iRob_ETH_Sch v26

Sheet: Ethernet

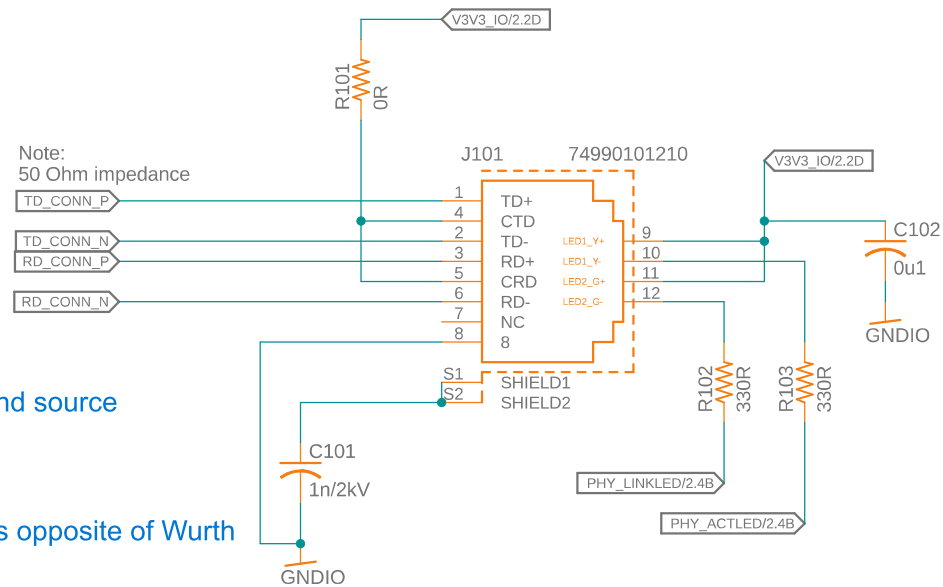
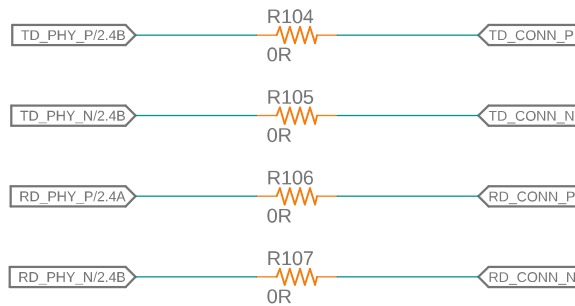
TODO:

- Change R 0402 to 0605
- Add the jumper resistor for RD+/- pin and LED to make it 2nd source with HanRun Mag jack
- >RD_CONN_P Würth use pin 3
- >RD_CONN_P HanRun use pin 7
- >LED Yellow polarity on HanRun is opposite of Würth
